Serial No. 04-270
ESP/JDH
Docket No. 52-008

DOMINION NUCLEAR NORTH ANNA, LLC
NORTH ANNA EARLY SITE PERMIT APPLICATION
RESPONSE TO REQUEST FOR ADDITIONAL INFORMATION NO. 3

Response to NRC RAI Letter No. 3

Figure 1. Map showing general area of coverage of Obermeier and McNulty (1998) liquefaction study relative to interpretations of the Central Virginia Seismic Zone.

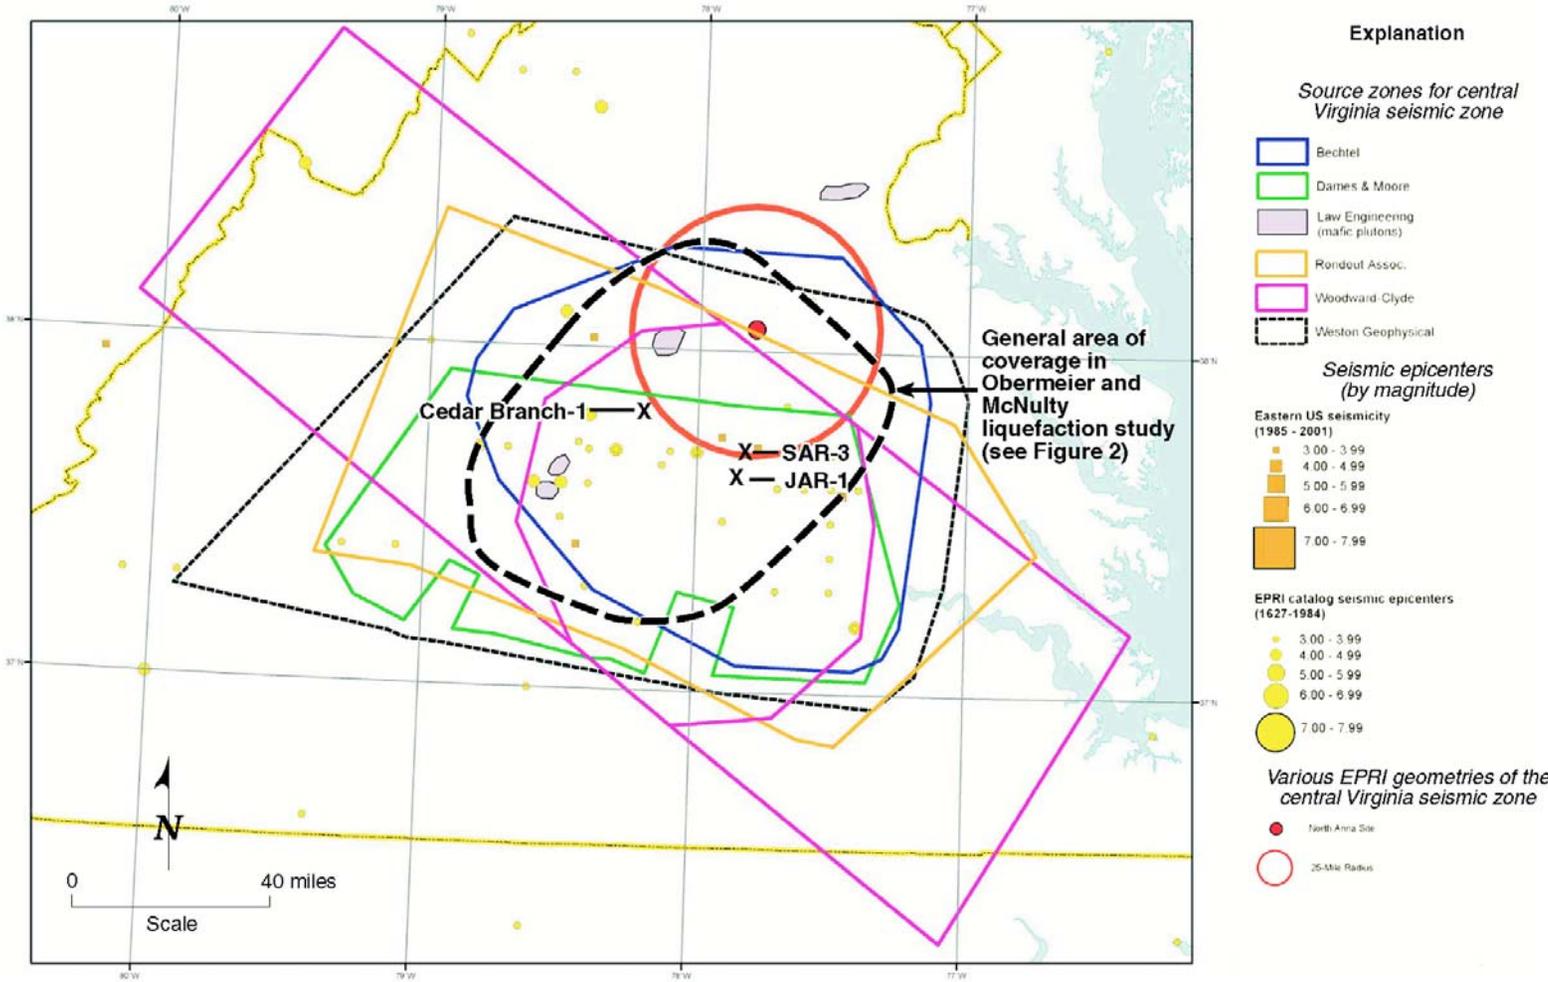
- c) Considering that the CVSZ is the major contributor to the hazard at the ESP site, please provide the following additional information:
 - i) a map showing the locations of the paleoliquefaction features relative to the ESP site,
 - ii) evidence that supports the stated ages of the liquefied sediments,
 - iii) specific locations, dimensions, and characteristics of the liquefaction features, and
 - iv) extent of the CVSZ covered by the study.

Location. A map showing the general area covered by the Obermeier and McNulty, 1998 study relative to the location of the North Anna site and the Central Virginia Source Zone as identified by the EPRI teams is shown on Figure 1. [Figures are located at the end of the RAI response.] A detailed map showing the locations of rivers canvassed by Obermeier and McNulty (1998) in relation to the North Anna ESP site is shown in Figure 2. This figure is modified from a figure produced by Obermeier for presentations, but never published. Figure 2 shows the locations of the liquefaction features identified during the study, as well as the locations of exposures of middle to late Holocene liquefiable deposits along rivers that did not contain liquefaction features. In general, more than 300 kilometers of rivers were examined by canoe in the summer of 1997 following a severe drought that revealed extensive exposures of stream banks that are rarely exposed. In recent discussions however, Dr. Obermeier indicated that parts of the North Anna River were surveyed following a rainstorm, such that high water submerged many exposures along the river and prevented continuous evaluation. As shown on the map, the liquefaction study area included many river segments over a broad regional area encompassing a large part of the CVSZ as identified by the EPRI teams.

Figure 1. Map of the East Coast fault system (ECFS, thick black lines), taken from Marple and Talwani (2000). CFA = Cape Fear arch; NFA = Norfolk Arch.

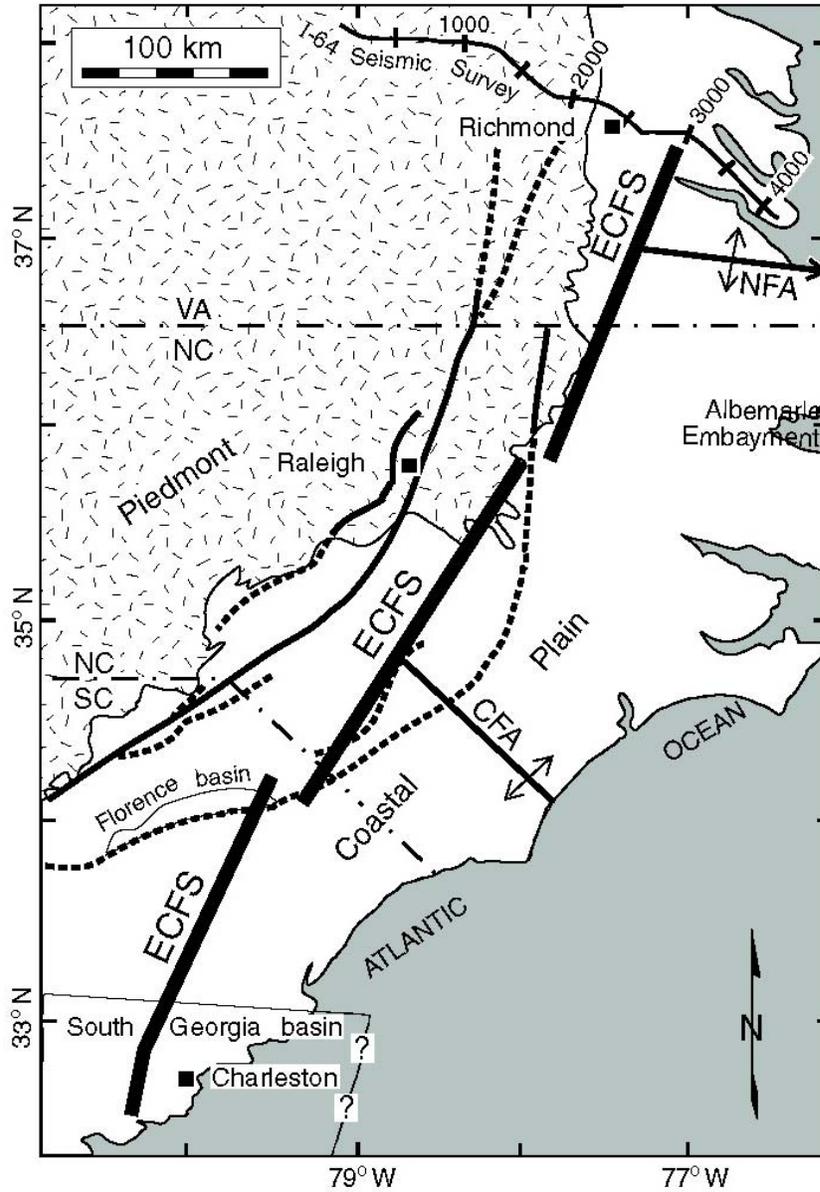
In SSAR Section 2.5.1.1.4, Dominion concludes on the basis of several lines of evidence, including aerial reconnaissance, that the northern segment of the East Coast Fault System (ECFS) “probably does not exist or has a very low probability of activity if it does exist.” Please provide additional information on the nature of the aerial reconnaissance for the ECFS, including the area covered and the type of evidence used to conclude that the northern segment of the ECFS does not exist or has low probability of activity. Please explain how information gathered during the aerial reconnaissance and from other sources supports conclusions in the SSAR that appear to be inconsistent with those made in the detailed geomorphic analysis of Marple and Talwani (Reference 74).

Marple and Talwani (2000) draw on geological, geophysical, seismological and geomorphic evidence to support their interpretation of the presence, location and activity of the ECFS. The location of the ECFS as described by Marple and Talwani (2000) is shown in Figure 1. [Figures are located at the end of the RAI response.] A detailed map of the northern segment of the ECFS is shown in Figure 2.

Figure 3. Longitudinal profiles of the Rappahannock River and the Pliocene Tps unit across the Tidewater fall line at Fredericksburg. The Tps surface has a constant gradient and extends across the fall zone in the river without obvious east-down deflection.

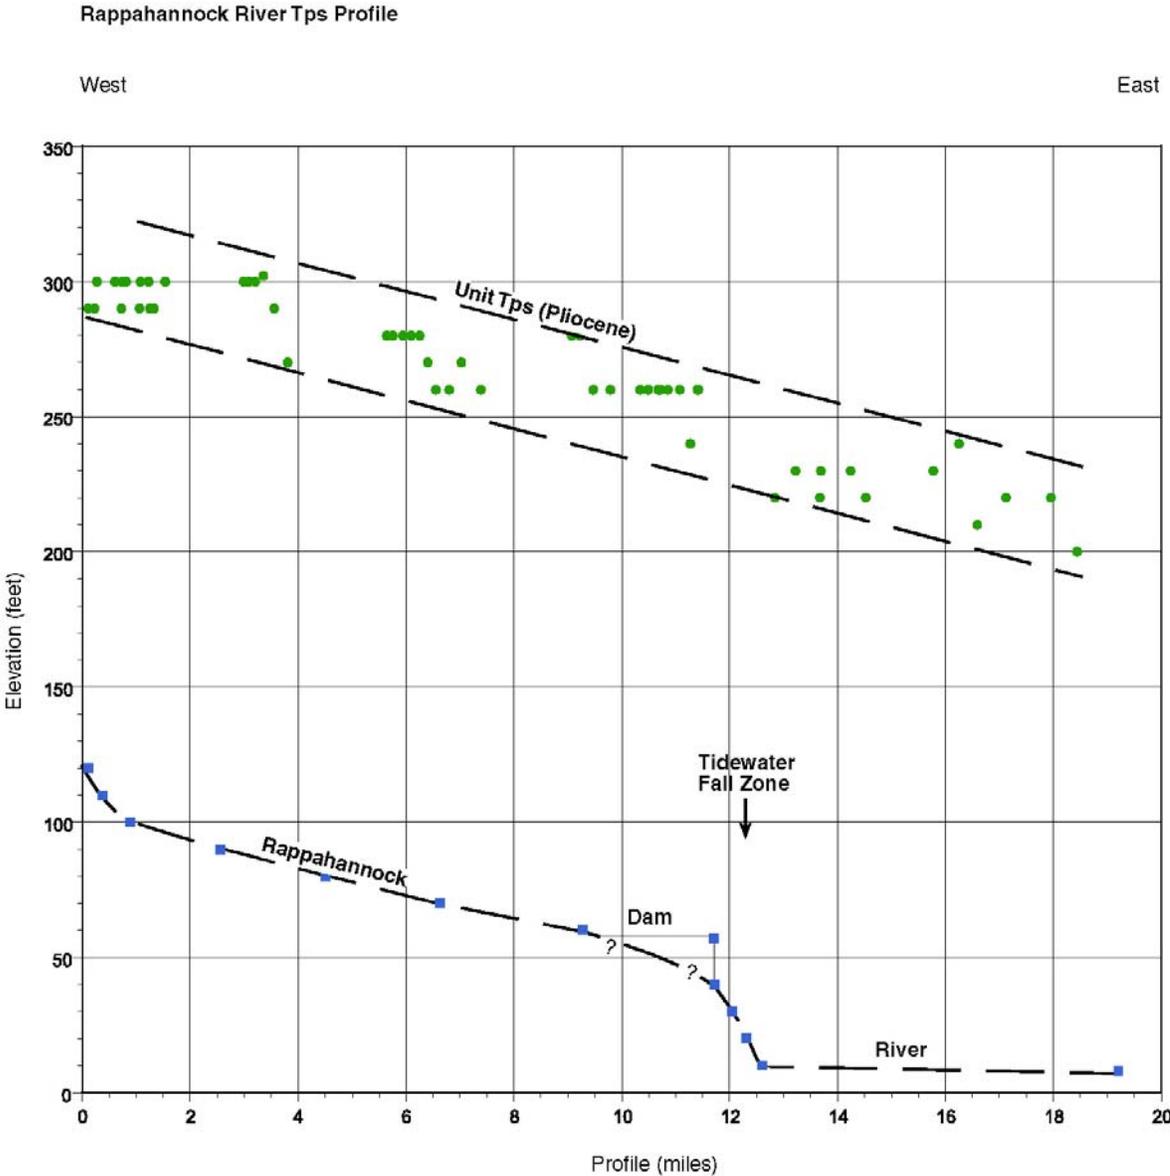
In SSAR Section 2.5.1.1.4, Dominion concludes that the seven fall lines defined by Weems (Reference 70) do not “represent a capable tectonic source.” Weems (Reference 70) favors a neotectonic origin for the seven fall lines. Please provide additional justification to confirm or disprove the seven fall lines defined by Weems (Reference 70) as a capable tectonic source. Also, please explain how the absence of these features in the compilation of Crone and Wheeler (Reference 59) demonstrates that the fall lines are not capable tectonic sources.

To assess the presence or absence of Quaternary tectonic activity along the Tidewater fall line, a detailed longitudinal profile of the Rappahannock River was prepared across the fall zone at Fredericksburg (Figure 3). In addition, elevations were plotted of remnants of a regressive late Pliocene marine sand (Unit Tps of Mixon et al., 2000), which cap upland surfaces of the inner Coastal Plain in northern Virginia, and specifically underlie the flattish, accordant summit surfaces north and south of the Rappahannock River, upstream and downstream of Fredericksburg (Figure 3). Although there is some scatter in the elevations of the Tps remnants on the profile, they generally define an east-sloping surface with a constant gradient that crosses the Tidewater fall zone on the Rappahannock River without obvious east-down deflection. Therefore, the Tps unit does not appear to be deformed across the Tidewater fall line at Fredericksburg. The gradient of the Tps surface is similar to that of the modern Rappahannock River upstream of the fall zone. If this interpretation that the Tps unit is not deformed is correct, then development of the fall zone in the river, which clearly postdates deposition of the Tps unit, must be due to non-tectonic geomorphic processes.

While acknowledging that there is uncertainty in the elevations of the Tps unit (as represented in a qualitative manner by the scatter in the points plotted on Figure 3), the total vertical scatter in the Tps elevations on Figure 3 of about 12 m (40 ft) is similar to the total relief on the Holocene channel of the Rappahannock River across the fall zone of about 15 m (50 ft). Although it is difficult to estimate original topographic relief across the fall zone with precision because a dam has been built at the top of the fall zone (Figure 3), the height of the fall zone appears to be comparable to or greater than the maximum scatter in the Tps elevations. If the fall zone is a scarp formed by east-side-

Figure 1. Sensitivity to ground motion model, 2.5 Hz

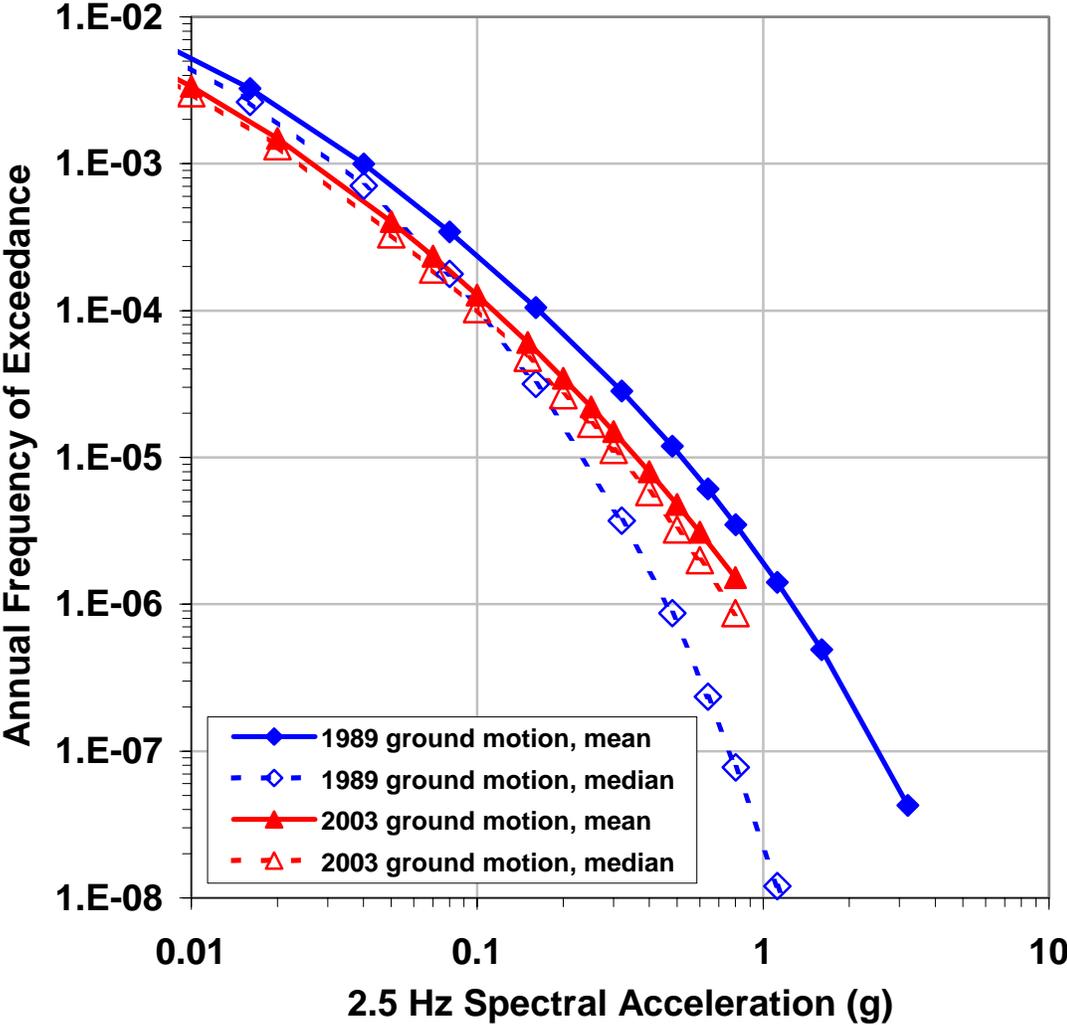
- a) Please provide hazard curves for 2.5 and 5 Hz spectral acceleration similar to those provided in the SSAR for 1 Hz (Figure 2.5-45) and 10 Hz (Figure 2.5-44).

The requested hazard curves are provided in Figures 1 and 2 on the next 2 pages. These curves were calculated just as were the 1 Hz (Figure 2.5-45) and 10 Hz (Figure 2.5-44) curves of the SSAR except that attenuation relationships appropriate for 2.5 Hz and 5 Hz ground motions were used.

Figure 1. Spectrum scaled to 1 and 2.5 Hz using $M=7.5$, $R=500$ km, compared to similar spectrum using $M=5.6$, $R=37$ km, to spectrum scaled to 5 and 10 Hz using $M=5.3$, $R=23$ km, and to performance-based spectrum.

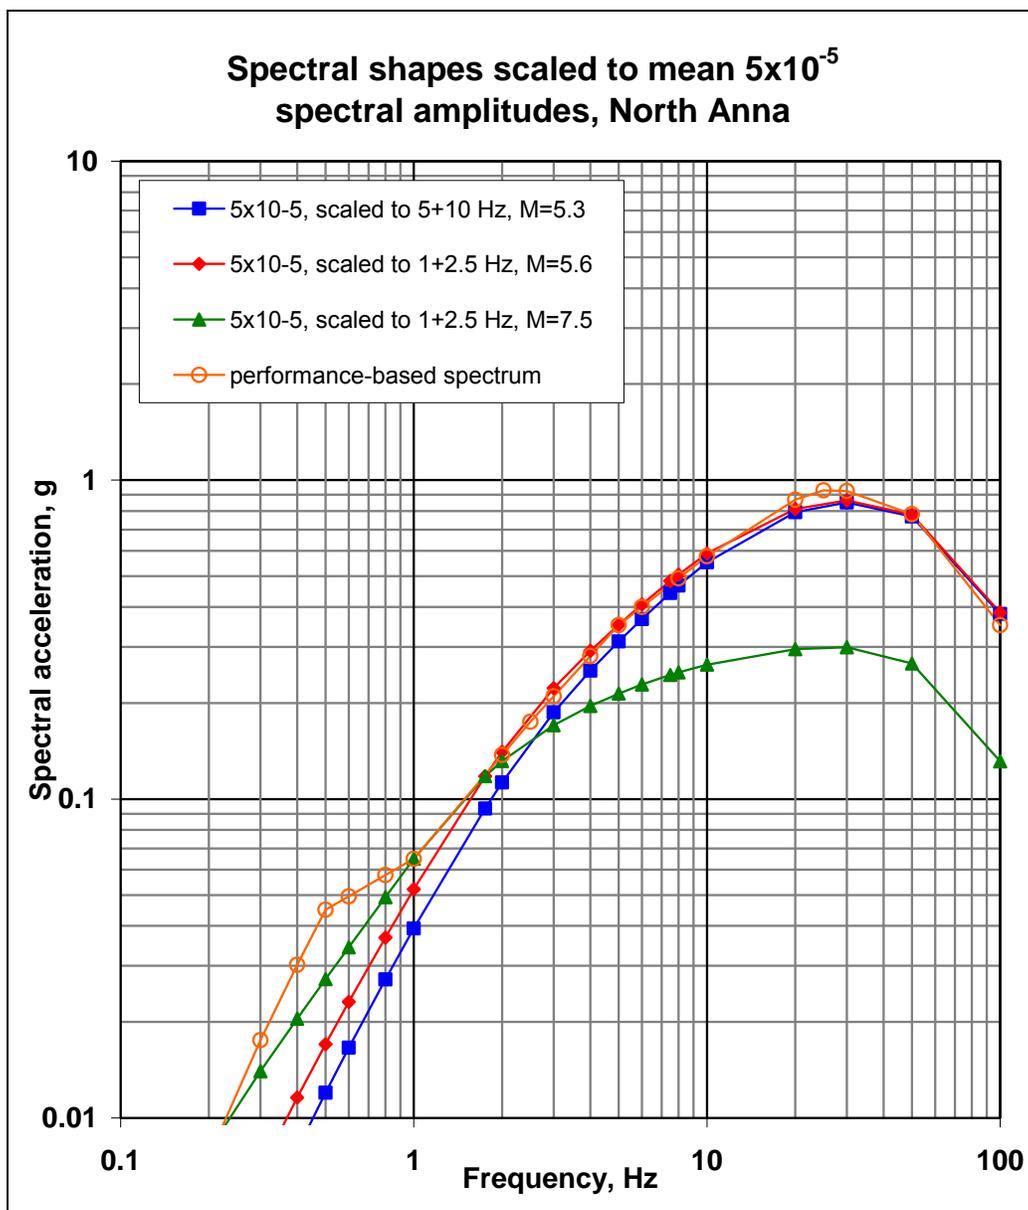
Regarding new seismic source characterizations, SSAR Section 2.5.2.6.3 states that, for the Charleston seismic source, the USGS source parameters (Reference 127) were adopted. SSAR Section 2.5.2.2.9 states that “the most significant impact of the 2002 USGS model (Reference 127) on seismic hazard for the ESP site is the updated Charleston sources parameters.” Figures 2.5-40 and 2.5-41 show 1 Hz spectral acceleration seismic hazard curves (median and mean, respectively) at the ESP site for the northern and southern segments of the East Coast Fault System (ECFS). As shown in both of these figures, the southern segment of the ECFS (ECFS-S), which includes the Charleston seismic source, makes a significant contribution to the overall hazard at the 1 Hz spectral acceleration. In spite of the significant contribution of the ECFS-S for low frequency ground motion, the controlling earthquake for the 1 and 2.5 Hz frequency range is a magnitude 5.5 earthquake at a distance of 30 km from the ESP site (Table 2.5-26). Neither this magnitude nor this distance correspond to an event occurring in the ECFS-S (i.e., Charleston source zone). Please explain this result in view of the statement quoted above and Figures 2.5-40 and 41 in the application.

If a large-magnitude, distant earthquake were to be adopted as a controlling earthquake for low frequencies, the primary effect would be a small increase below the 1-to-2.5 Hz control frequency point in the SSE spectrum. This is illustrated in Figure 1. This plot shows a low-frequency spectrum scaled to the average of the 1 and 2.5 Hz amplitudes for a mean hazard of 5×10^{-5} , using $M=7.5$ and $R=500$ km (the green triangles). The low-frequency spectrum developed in the SSAR used $M=5.6$ and $R=37$ km (the red diamonds in Figure 1), representing the dominant contribution of the central Virginia seismic zone. The selected performance-based spectrum is also shown as orange circles. The $M=7.5$ spectrum lies below the $M=5.6$ spectrum at frequencies higher than 2 Hz, and lies below the selected performance-based spectrum at frequencies between 1 Hz and 0.2 Hz (few, if any, plant components are sensitive to these low frequencies). The high-frequency spectrum developed in the SSAR, which used $M=5.3$ and $R=23$ km (the blue squares in Figure 1), does not affect the SSE in the low-frequency range.
